UNITED STATES
NUCLEAR REGULATORY COMMISSION
WASHINGTON, D. C. 20555

LICENSEE: COMMONWEALTH EDISON COMPANY
FACILITY: ZION STATION, UNIT NOS. 1 AND 2
SUBJECT: SUMMARY OF OCTOBER 26, 1979 MEETING REGARDING INSPECTIONS FOR
FEEDWATER LINE CRACKING ON ZION UNIT NOS. 1 AND 2

Representation of Indications at Counterbore
Ramp Angle Found by Radiography

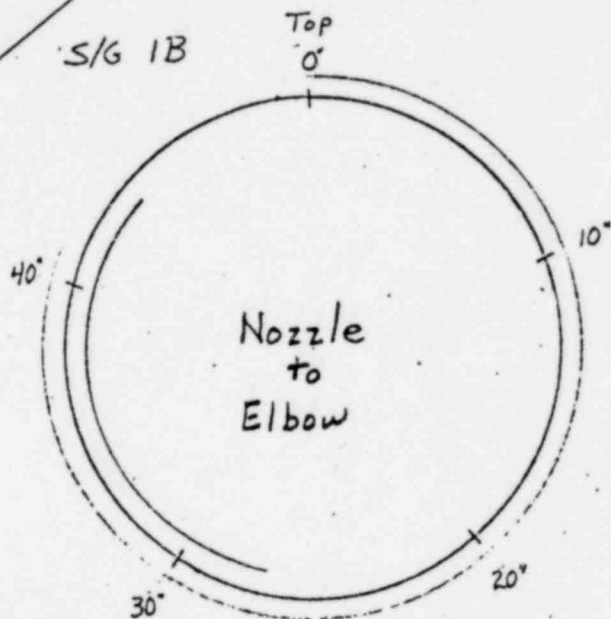
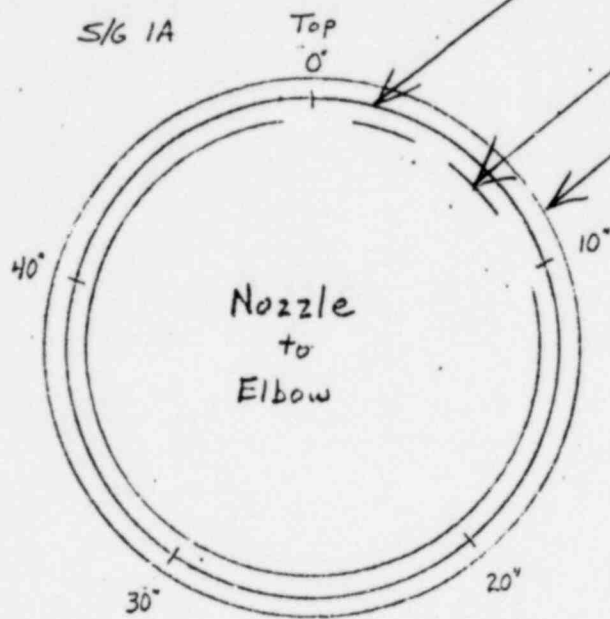
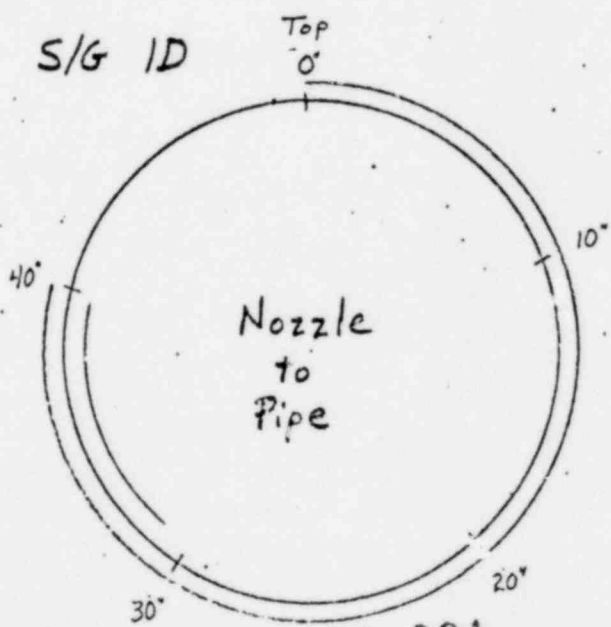
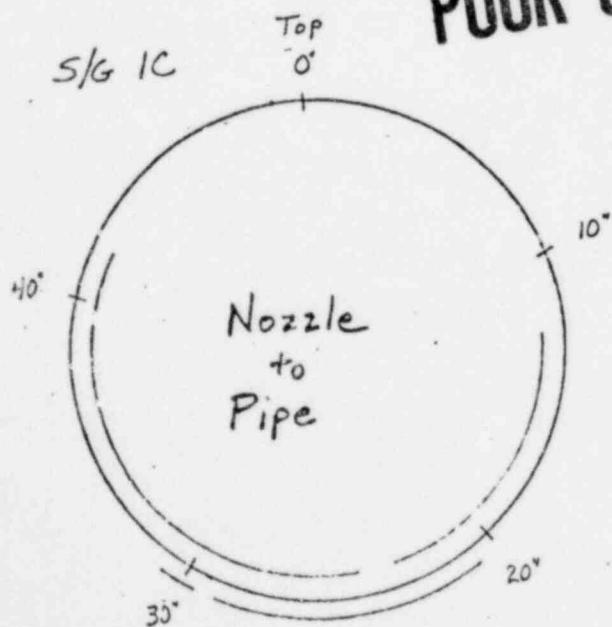
in the piping and nozzles. (The Engineering Branch of DOR will maintain a copy of sketches and other written data presented at the meeting by the licensee). Indications had been found on both sides of the weld in the areas shown on the attached sketch of SG1A through SG1D. Depths of indications had been estimated at less than 0.170 inches maximum. However, at the meeting, CECO could not give a definitive depth estimate. Westinghouse (E. Williams) estimated 0.060-0.090 inches in depth maximum.

1. Proceed to replace the affected feedwater piping for all loops on Unit No. 1 during the current outage.
2. Bring Unit 2 to shutdown condition as soon as the metalographic examination and the UT evaluation is completed on the Unit 1 specimen within a week to 10 days. Also perform inspections using latest techniques and then do an analysis to determine crack size, if existent.

FAILURE PREDICTIONS - 16 INCH SCH 120 PIPE - 1.09 INCH WALL

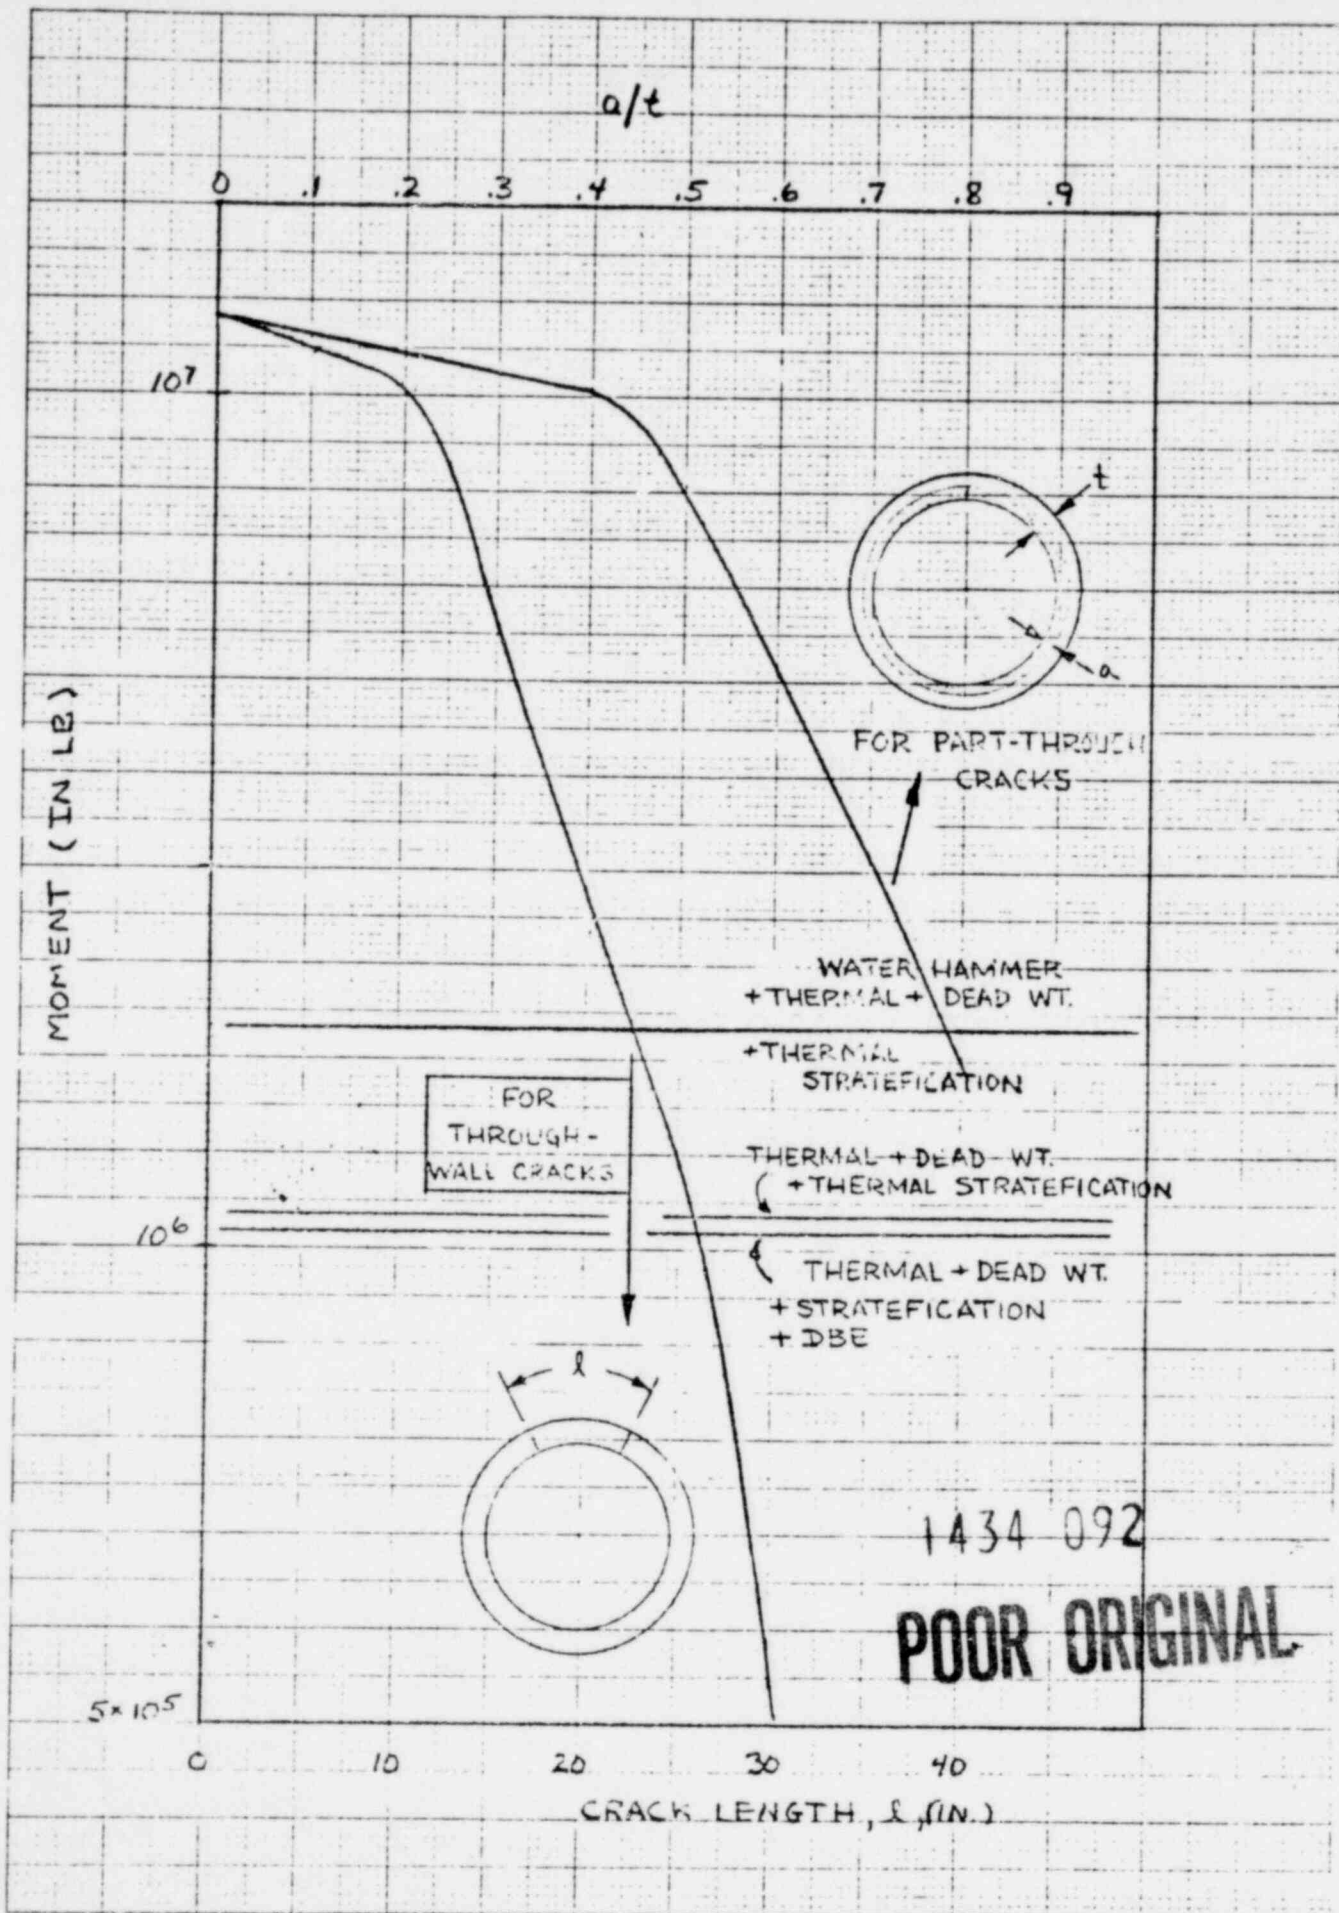
Mr. W. Bamford (Westinghouse) presented a Failure Prediction Analysis which showed combined water hammer load (previous reports) plus thermal and dead weight loads. With the aid of failure prediction curves (attached) Mr. Bamford indicated that pipe failure should not occur ever with an 80% through-wall crack for these combined loads. A discussion of Unit 2 status of examinations was held. CECO (Naughton) restated its position that the Unit 2 examinations should be delayed until the plant shuts down for an outage that had been scheduled to start on December 2, 1979. The NRC staff considered a more expeditious check is necessary.
